Technical Advisory Bulletin

Date: Thursday, November 20, 2008 Number: TAB-08-011

Notice: GS3060 & GS3055-ICF Trouble Supervision

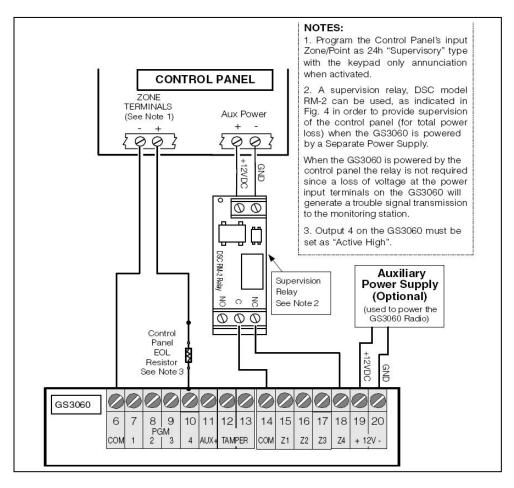
To ensure proper notification of troubles on the GS3060 & the GS3055-ICF, it is strongly recommended that output 4 on the GS3060 be connected to a zone on the control panel. The zone should be programmed as a 24 Hour Supervisory which will annunciate at the keypad when a GS3060 or GS3055-ICF trouble is present.

Detailed information on wiring output 4 to the zone is contained in the GS3060 Installation Manual in the Wiring Diagrams section and is reproduced below. This information is also pertinent to the GS3055-ICF.
